# GTS Newsletter

2009/07E

| <b>Machines</b>    | <b>TASKI swingo 750 / 1650 / XP</b> |

## Pump 24V

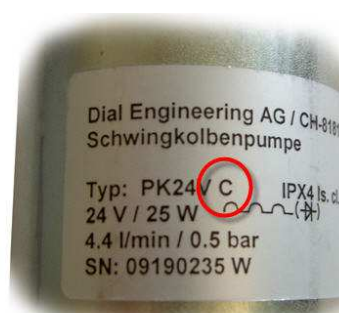
Feedbacks from the field have indicated that the current configuration of the pump is not always meeting the demands. Together with the supplier of the pumps the mechanical setup as well as the used materials were optimised.

| Description    | Material no.       | Remarks               |
|----------------|--------------------|-----------------------|
| Pump 24V (new) | 4123169 (17608-33) | Type „C“ (red marked) |

Pumps delivered as spare parts are type "C".
